Subject: **WATER AND WASTEWATER CAPACITY AVAILABILITY LETTER**
3016 Bayshore Drive – DRC R18058
3016 Bayshore Drive, Fort Lauderdale, Florida 33304

City of Fort Lauderdale
Public Works Department
Water and Wastewater Capacity Analysis
October 18, 2018

Project: 3016 Bayshore Drive
3016 Bayshore Drive, Fort Lauderdale, Florida 33304
DRC Case No. R18058

Figure 1 – City Water Atlas

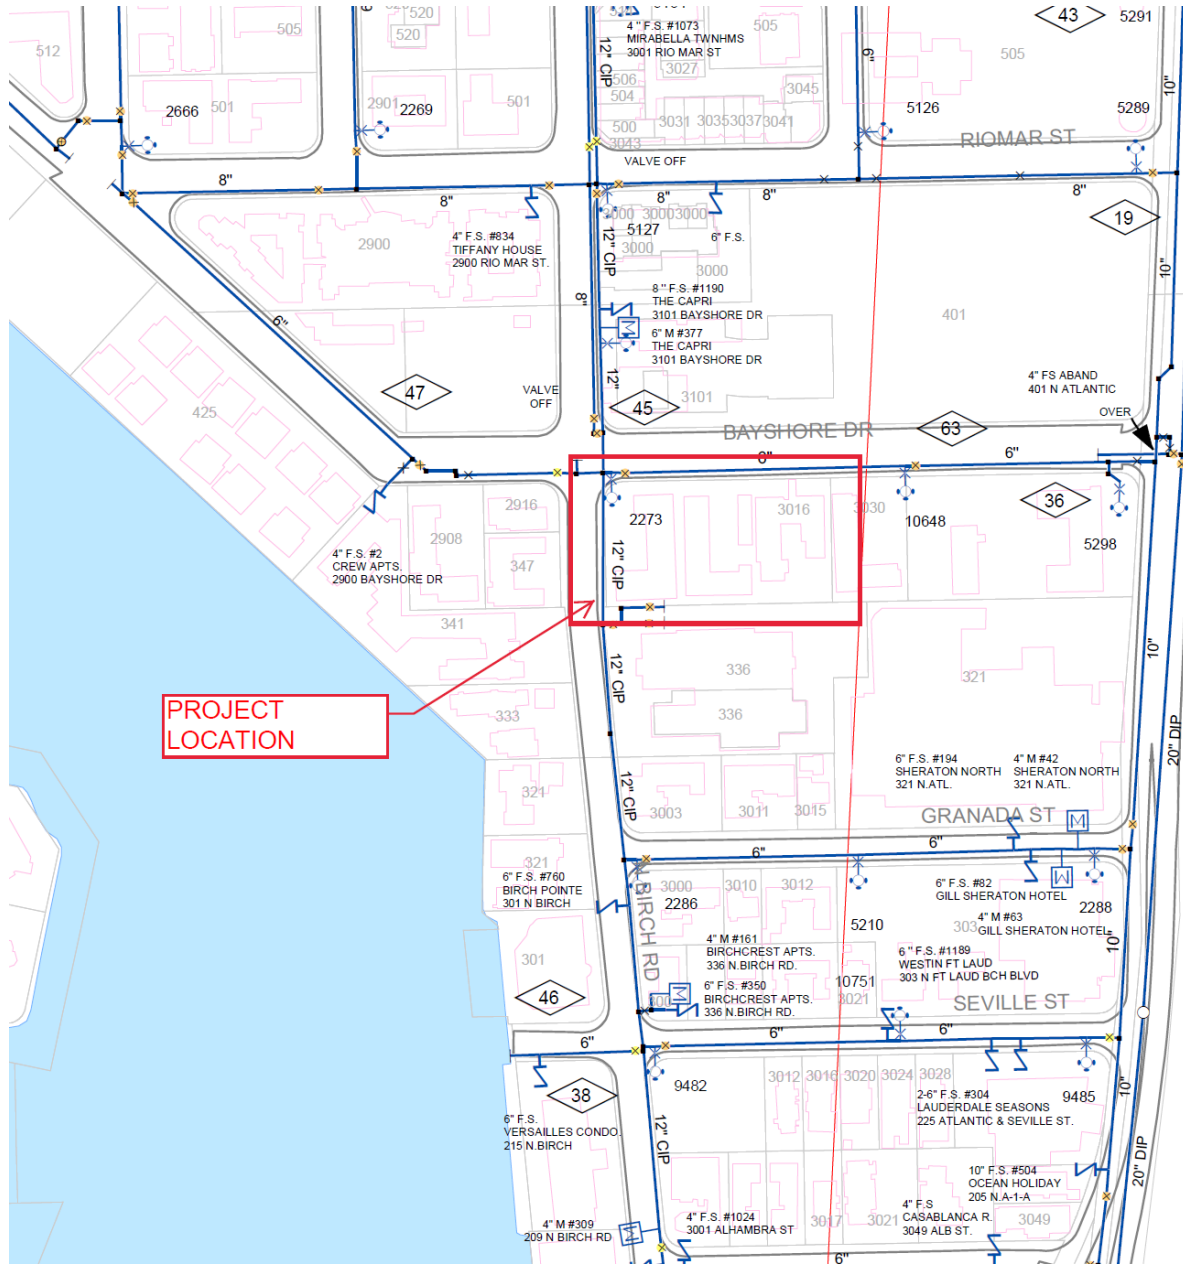
Water: The site is currently served by a 12-inch water main along North Birch Road, see Figure 1.

Evaluation of impact on existing distribution pipe (flow & capacity): According to the site plan the applicant is proposing to utilize the 12-inch water main on North Birch Road. The InfoWater hydraulic model was analyzed to determine the impact of this project on the existing 12-inch water main. The existing water main has capacity to serve the project.

Recommended Water Infrastructure Improvements: No improvements required.
